Point Beach Nuclear Plant, Units 1 and 2
Dockets 50-266 and 50-301
Renewed License Nos. DPR-24 and DPR-27

License Amendment Request 241
Alternative Source Term
Response to Request for Additional Information

LICENSE AMENDMENT REQUEST 241 ALTERNATIVE SOURCE TERM RESPONSE TO REQUEST FOR ADDITIONAL INFORMATION

BECH 6118 M-144 SH.2

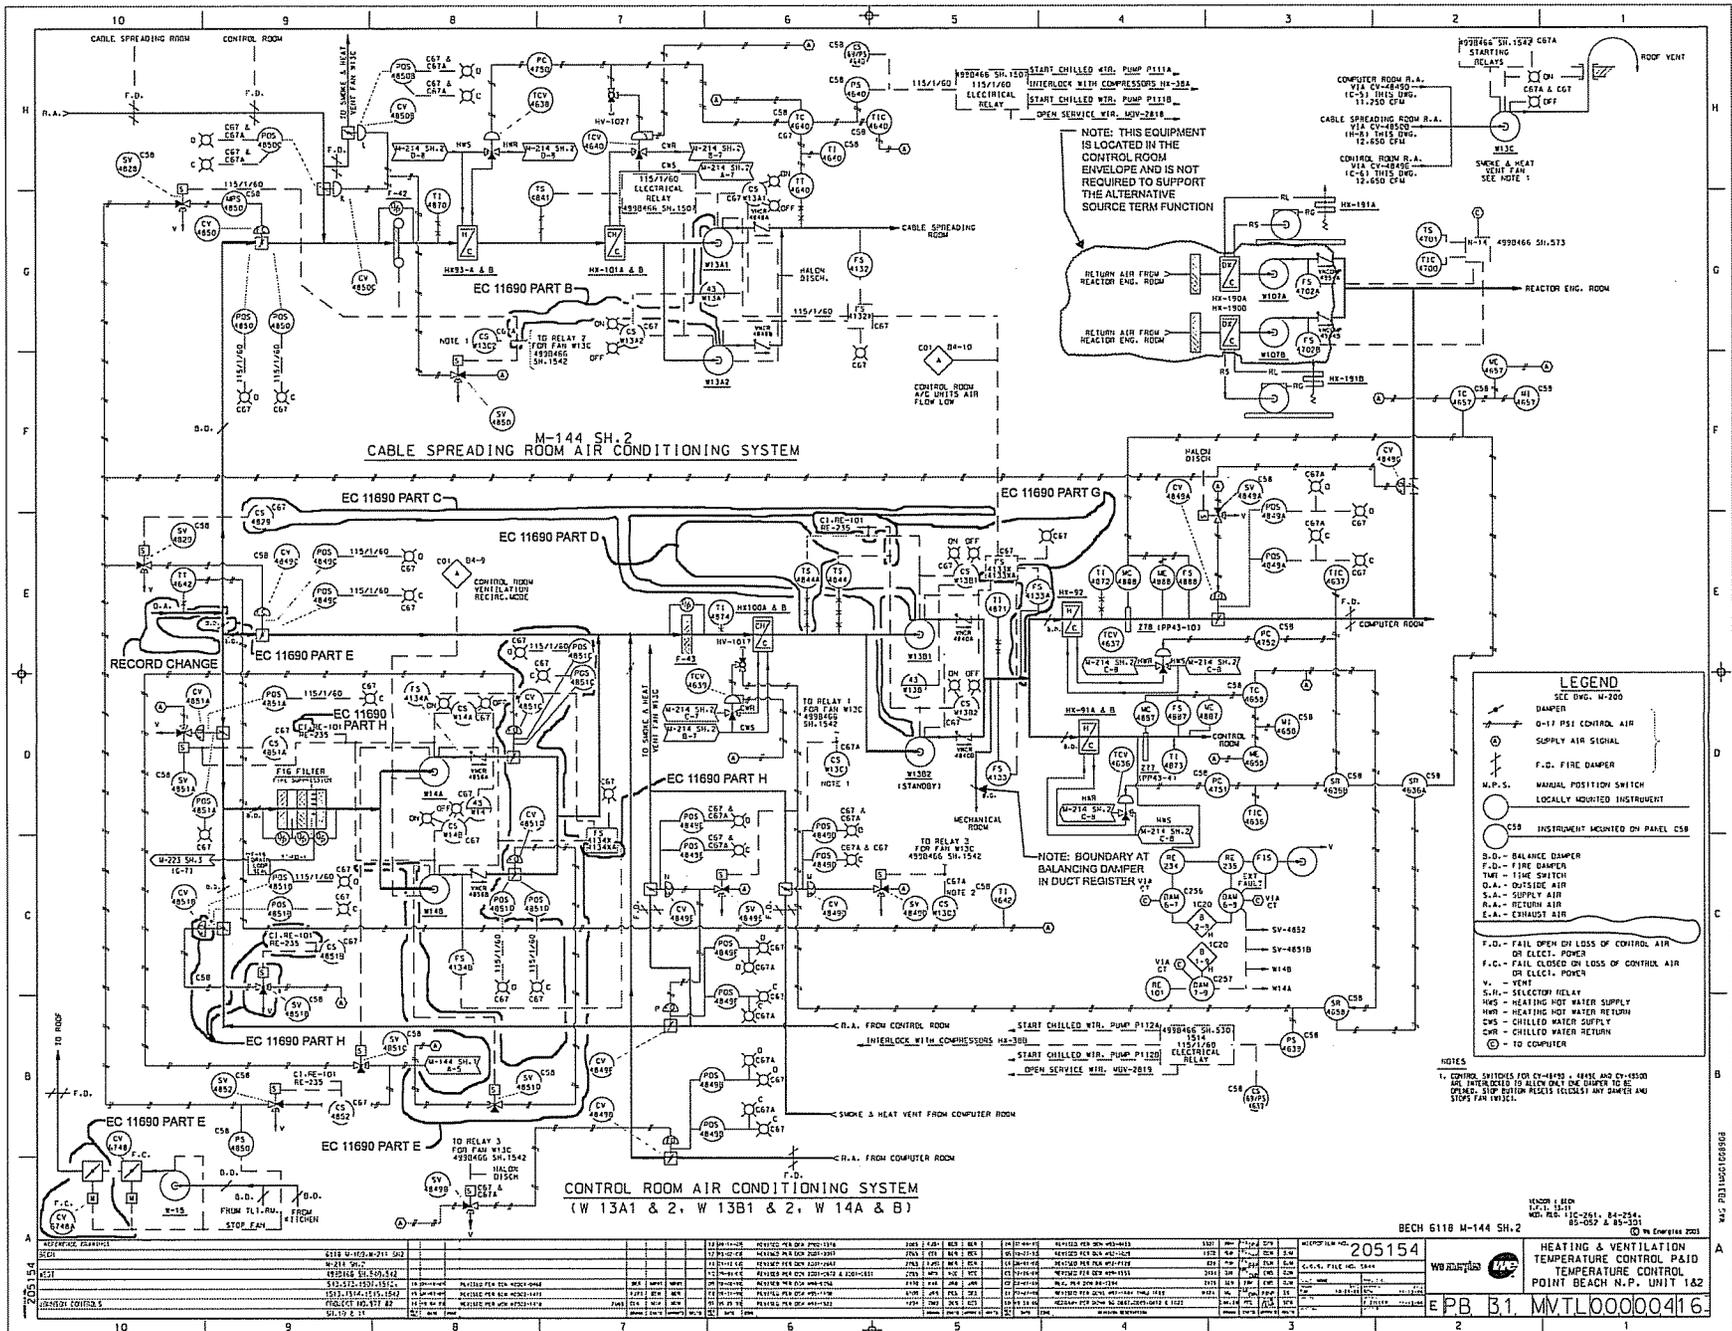
Provide the extent of the control room emergency filtration system (CREFS) and the primary auxiliary building ventilation system (VNPAB) that would be required to be functional to support the alternate source term (AST) licensing amendment request (LAR) by providing drawings suitably marked with the system boundaries and a list of structures, systems, and components that would be upgraded to augmented quality status. Include in the response, all new equipment that will be added to modify the CREFS and VNPAB to provide redundancy along with a discussion of the quality status to which such equipment will be designed, procured, installed and tested.

Drawings marked to show the system boundaries for the control room emergency filtration system (CREFS) and the primary auxiliary building ventilation (VNPAB) system are provided in Enclosure 2. Structures, systems, and components that will be classified as augmented quality (quality related) for CREFS and VNPAB are listed in Enclosure 3.

- FS-4133A (W-13B1/B2 control room recirculation fan low alarm flow switch)
- TS-4844A (HX-100A/B control room chilled water cooling coil temperature switch)
- W-13B1/B2 and W-14A/B fan control circuits
- VNCR-4851C/D (W-14A/B control room charcoal filter fan discharge control dampers)
